Shiprock Pinnacle Hotel & Restaurant

Highway 491 & Turquoise LN, Shiprock, NM 87420
Dyron Murphy Architects Project No. 2022.10

ADDENDUM No. 3

December 15, 2023

SIGNAGE PLAN - HOTEL

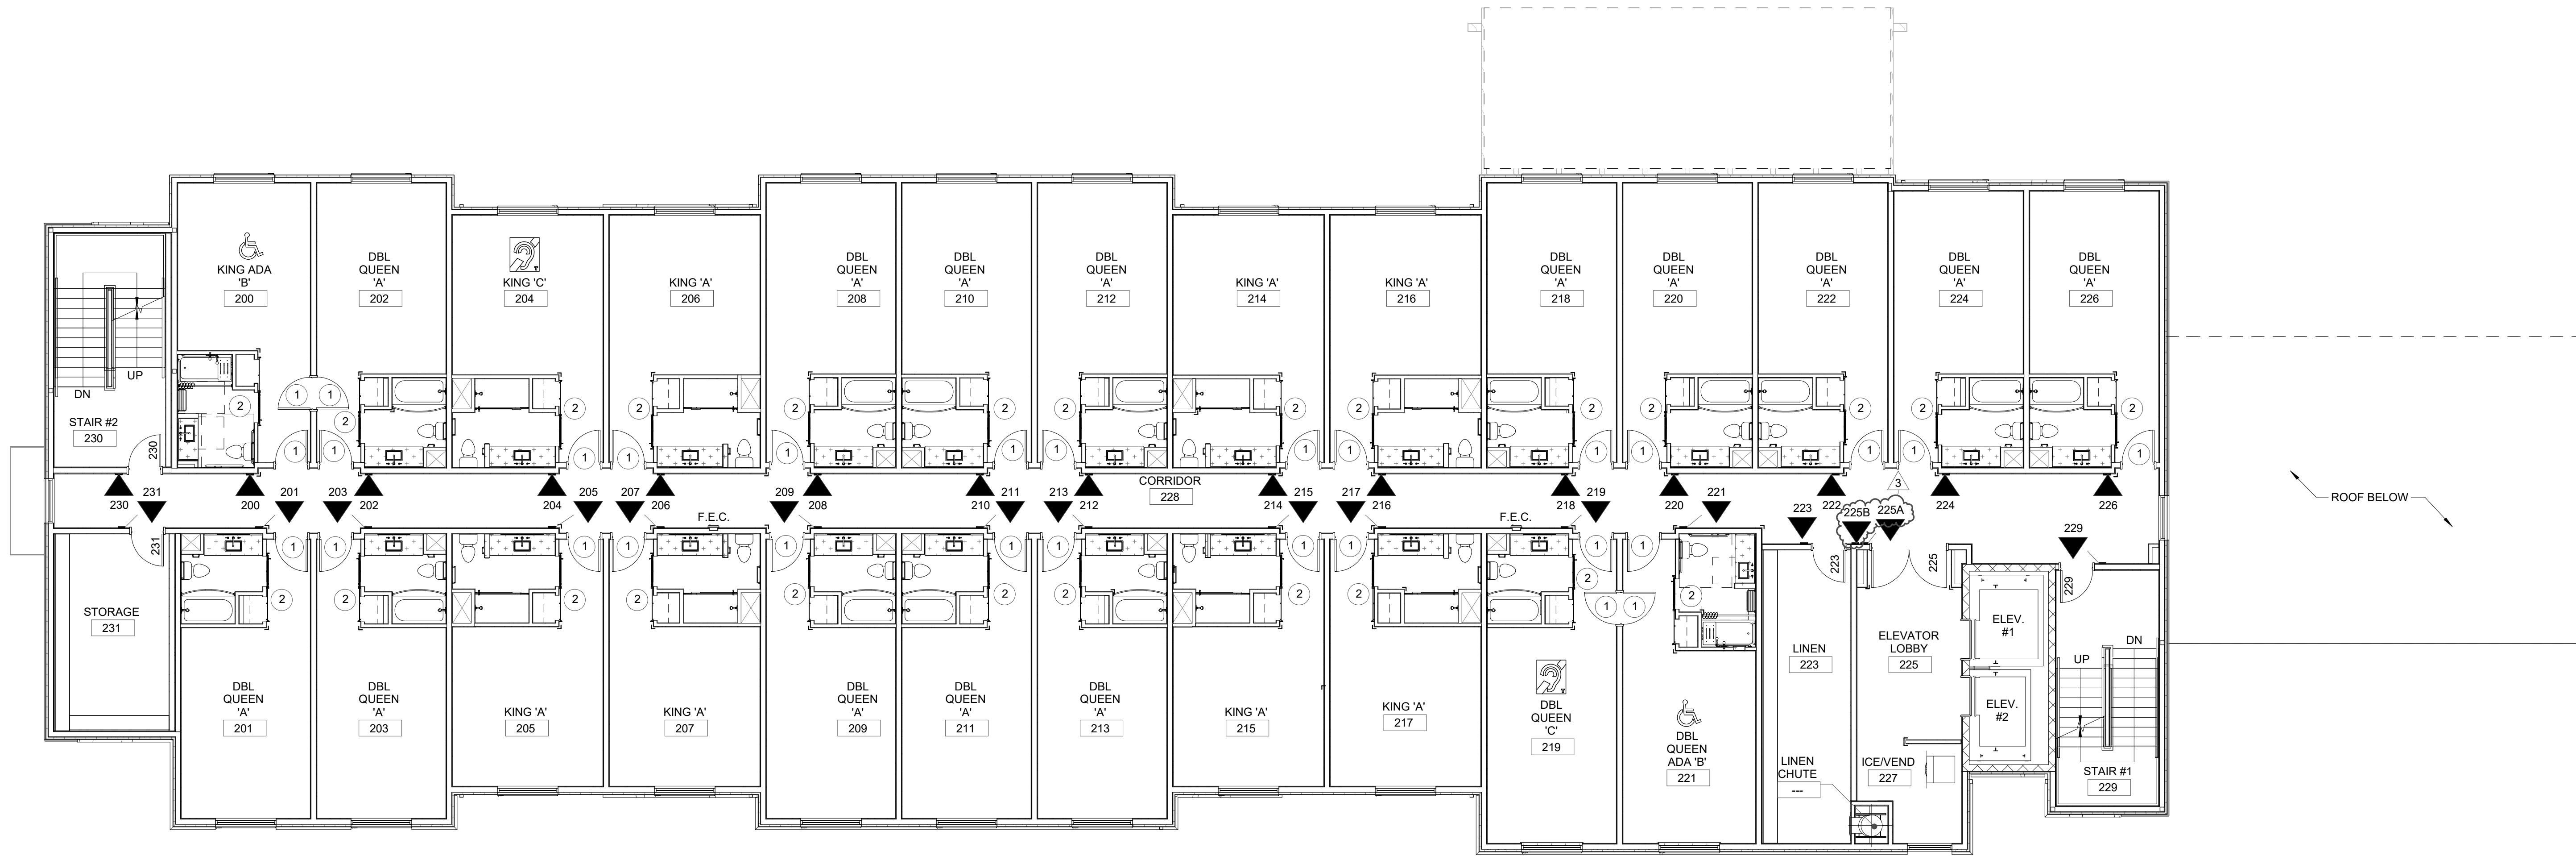
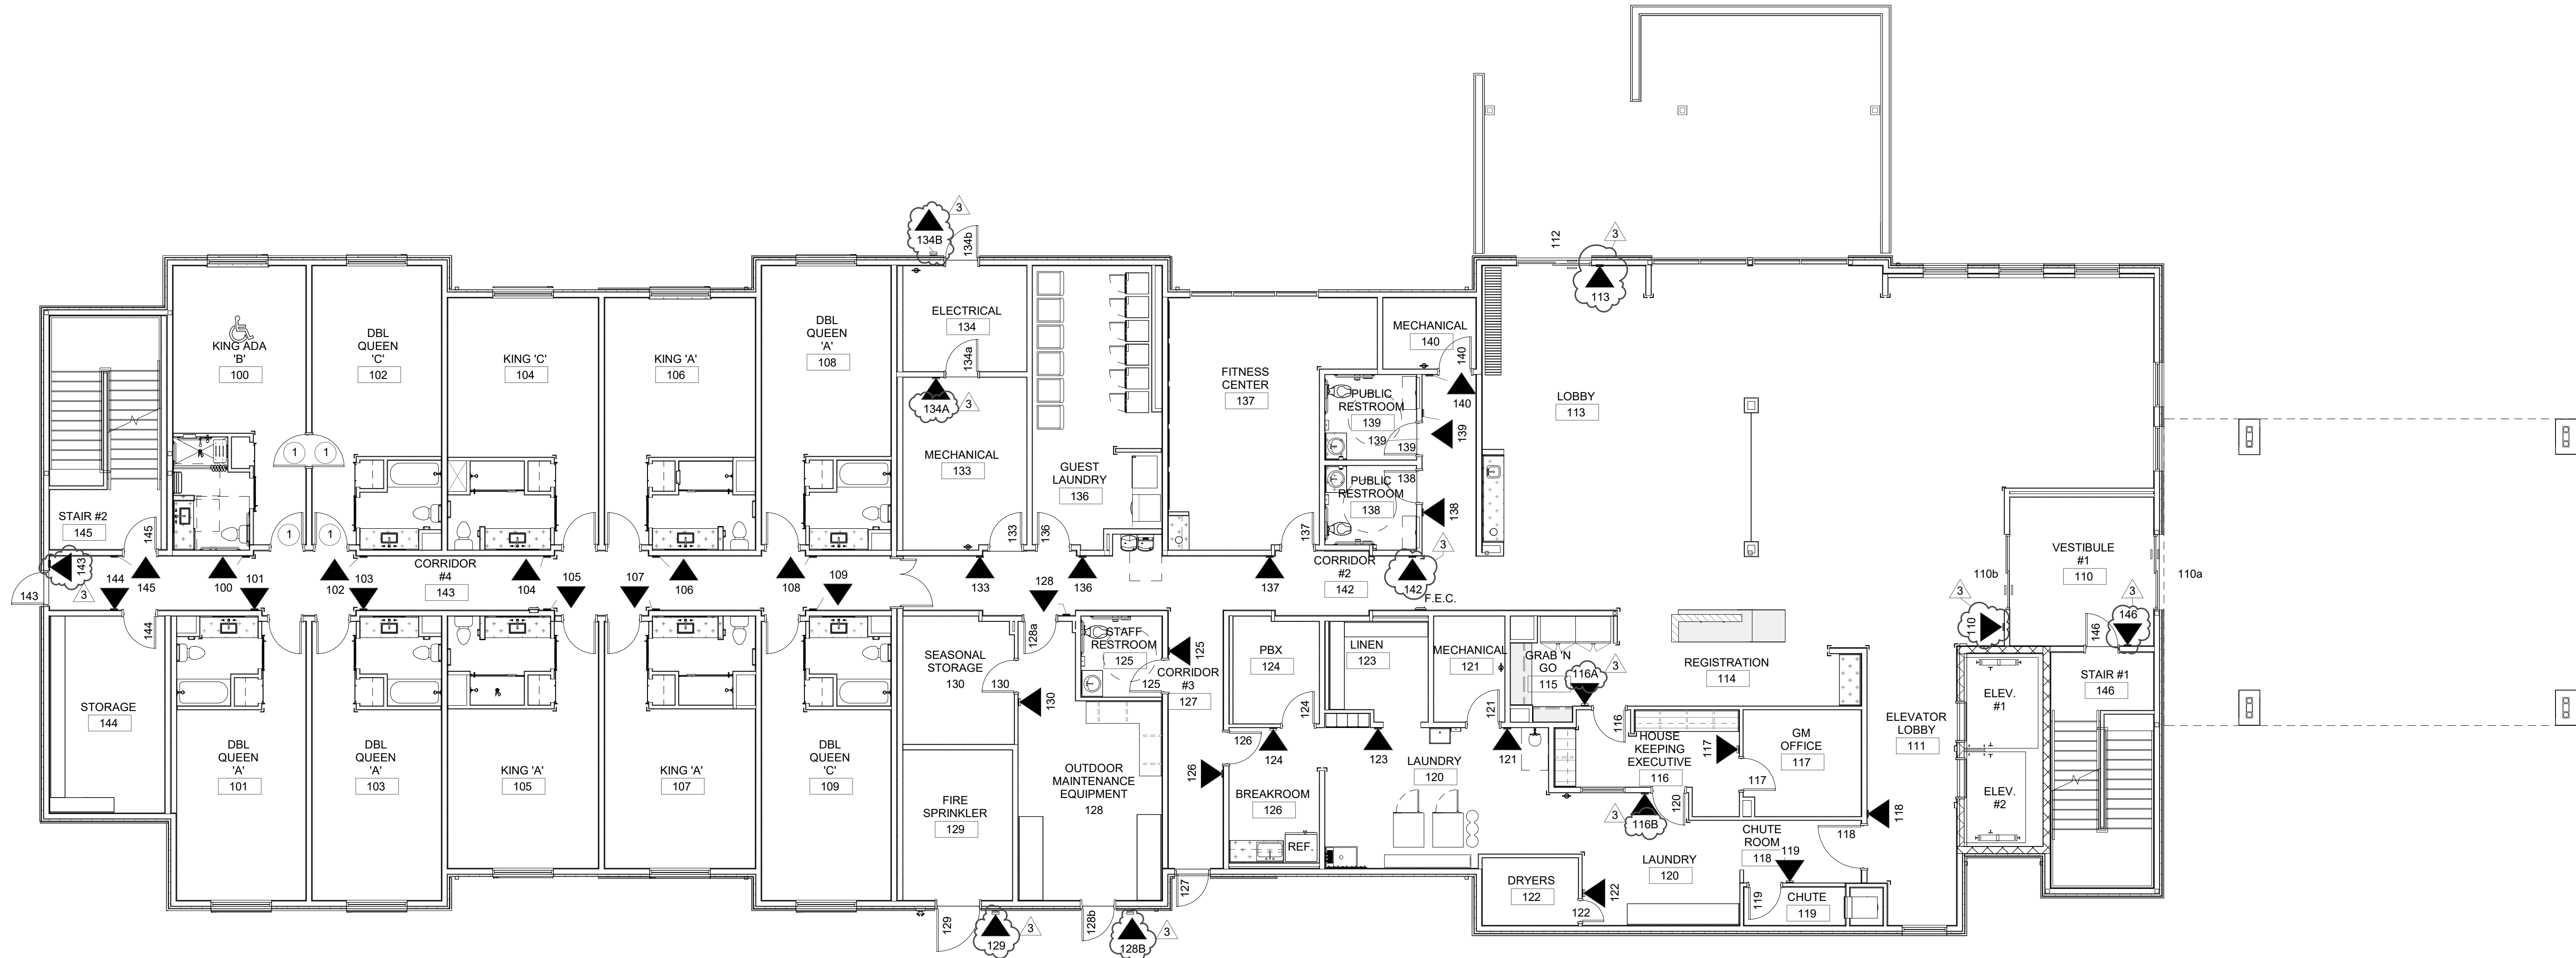
ID104 – SIGNAGE PLAN – HOTEL

- Added General Notes
- Revised Signage Legend
- Renamed duplicate sign numbers 116 to be 116A & 116B
- Renamed sign 225 to 225A and renamed sign 134 to 134A
- Added signs 110, 113, 128B, 134B, 142, 143, 146, & 225B

SIGNAGE PLAN - HOTEL

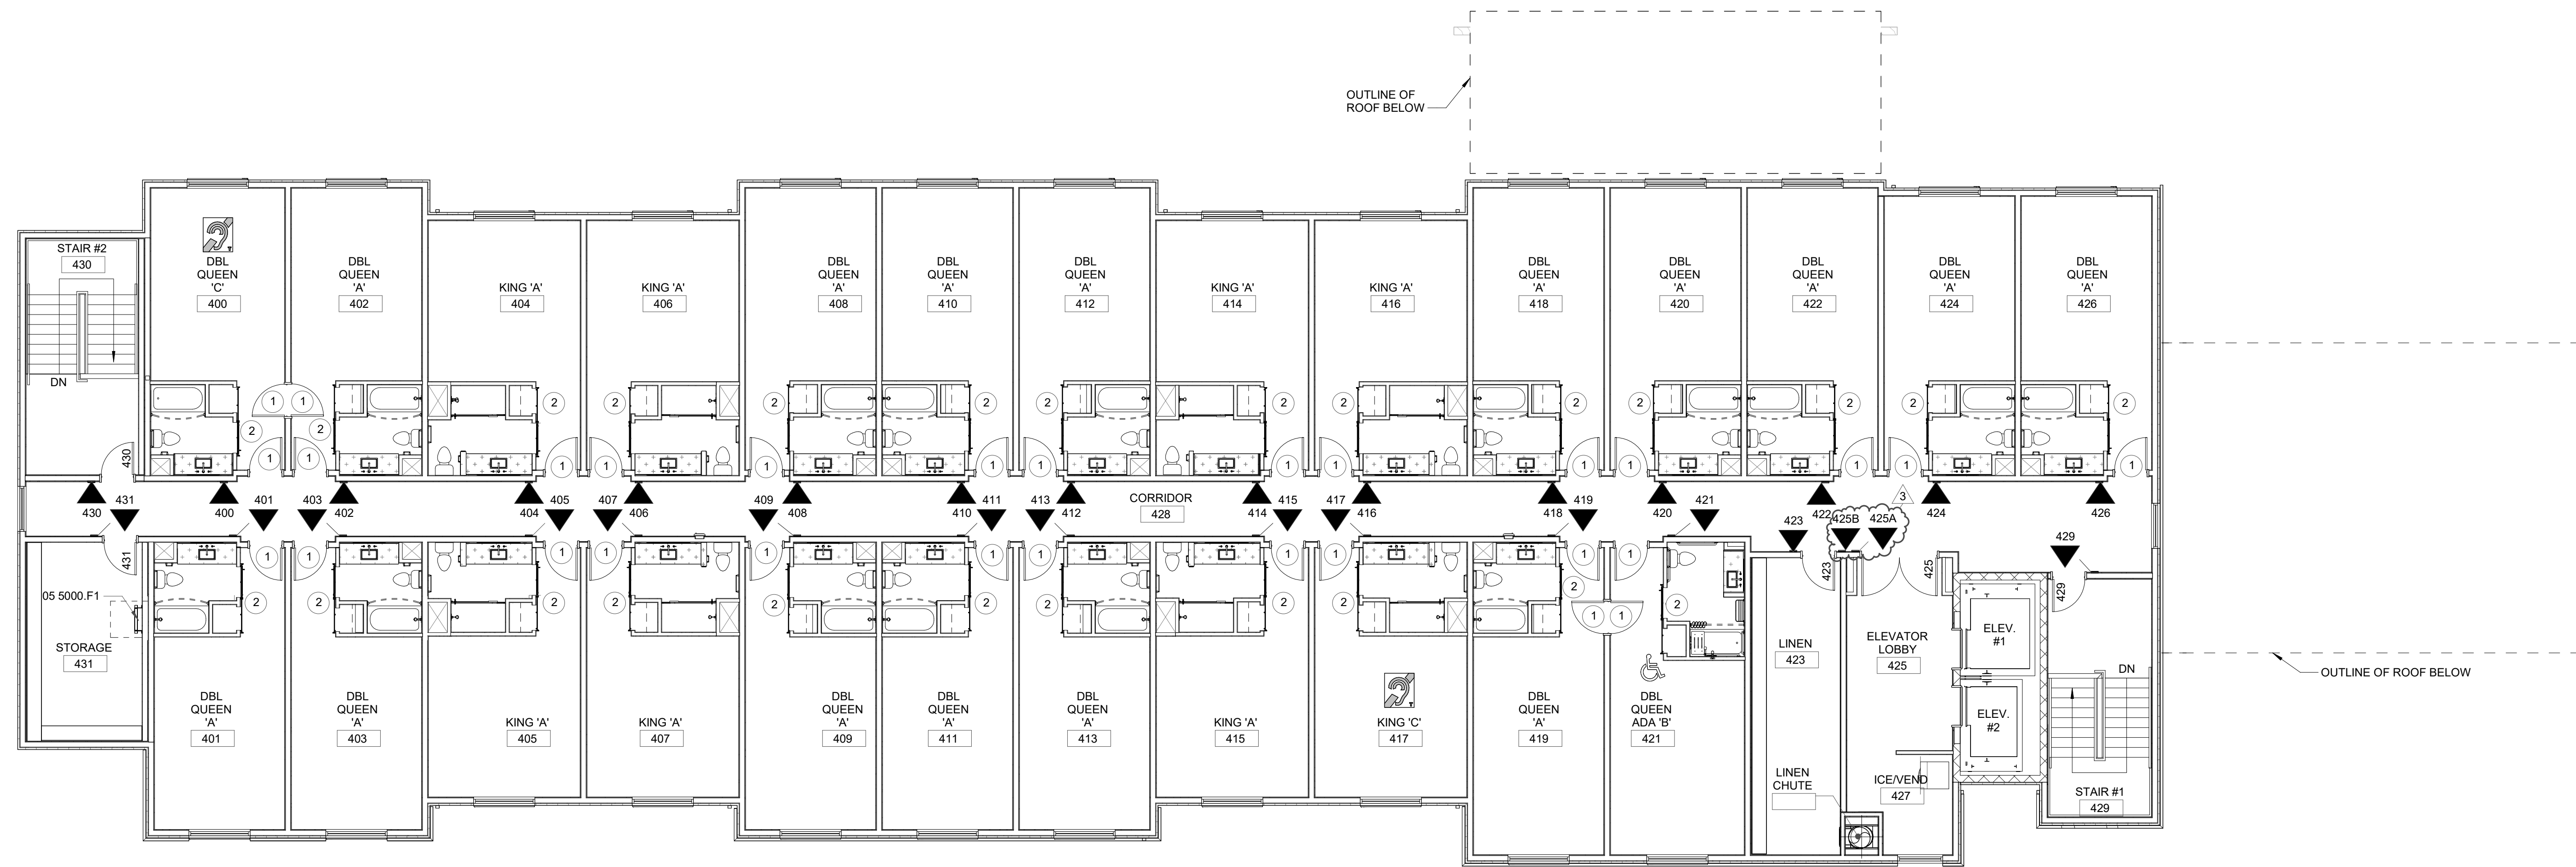
ID105 – SIGNAGE PLAN – HOTEL

- Added General Notes.
- Revised Signage Legend
- Renamed sign 325 to 325A
- Added signs 325B, 425A, & 425B

A6 SIGNAGE PLAN - RESTAURANT
3/16" = 1'-0"

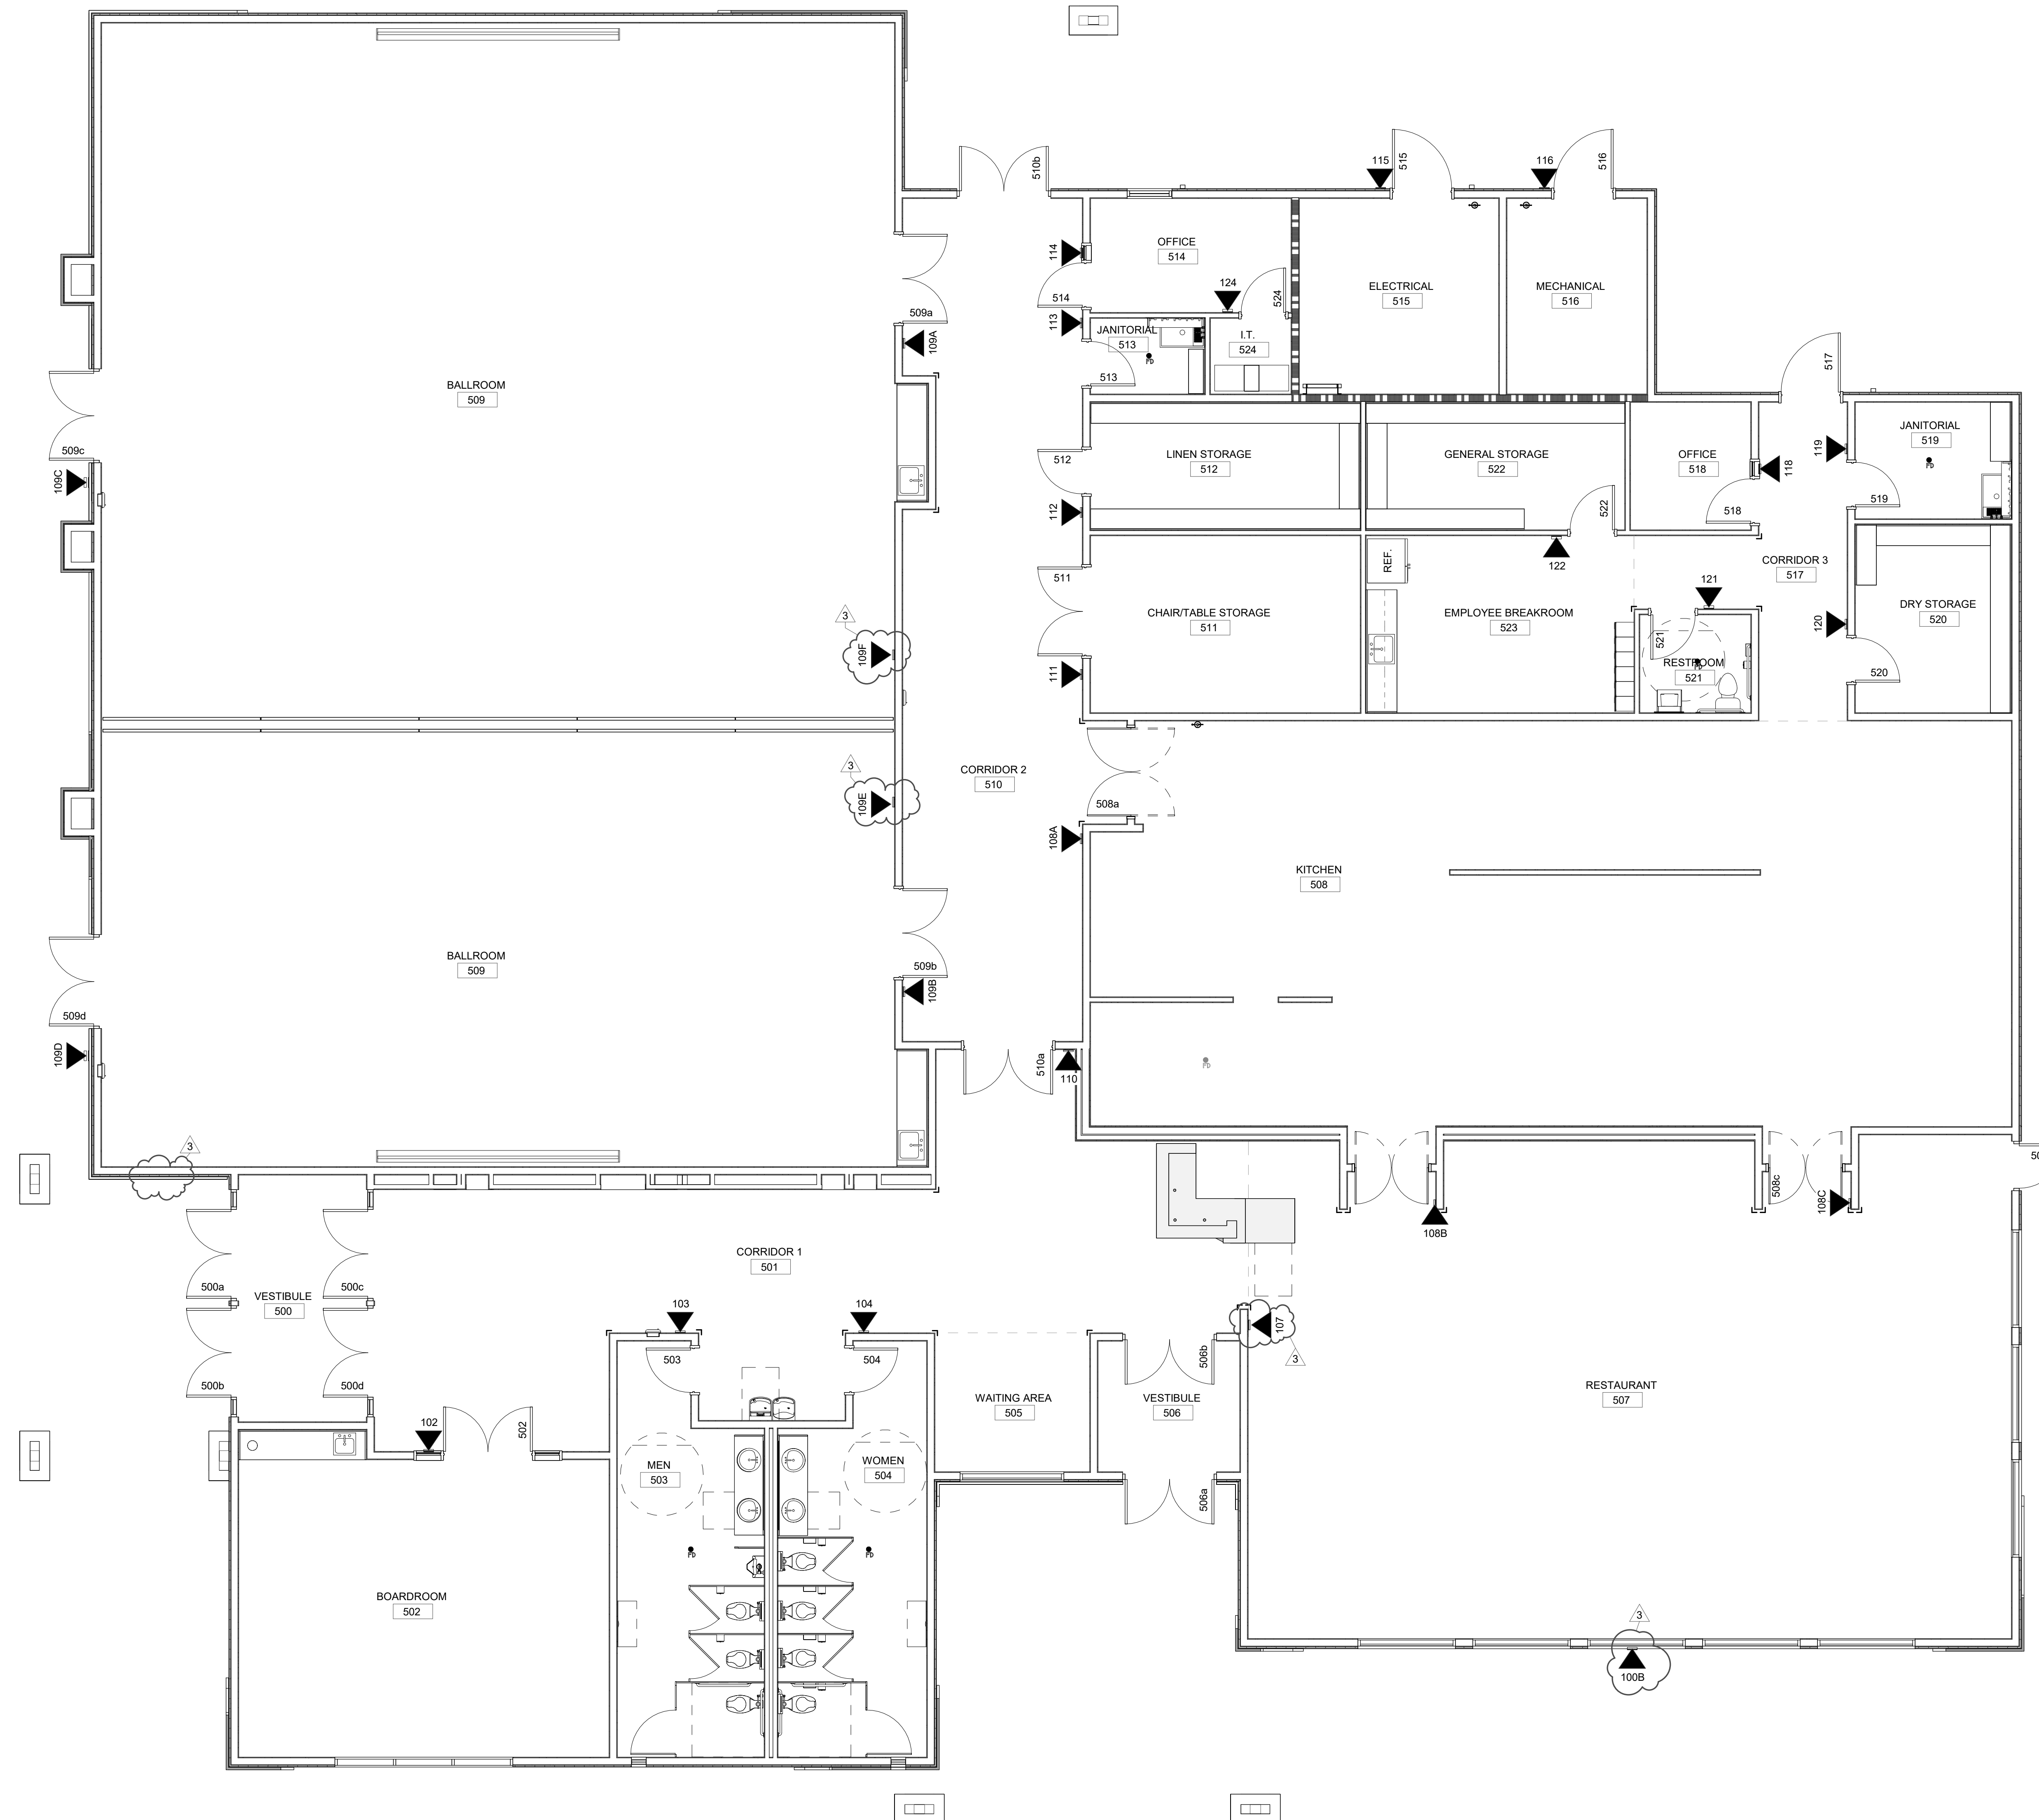
5. *Sheet ID106 Signage Plan Restaurant. Signage Tag 100B. Please confirm what this is to be. No dimensional letters seen on Restaurant Exterior Elevation sheets.*

ID106 – SIGNAGE PLAN – RESTAURANT

- Added General Notes
- Revised Signage Legend
- Removed sign 100A
- Relocated sign 100B
- Added signs 107, 109E, & 109F

Tag 100b is for exterior signage. Text and logo to be determined by owner. Location has been revised. See sketch A05 for updated south elevation B6/A203.
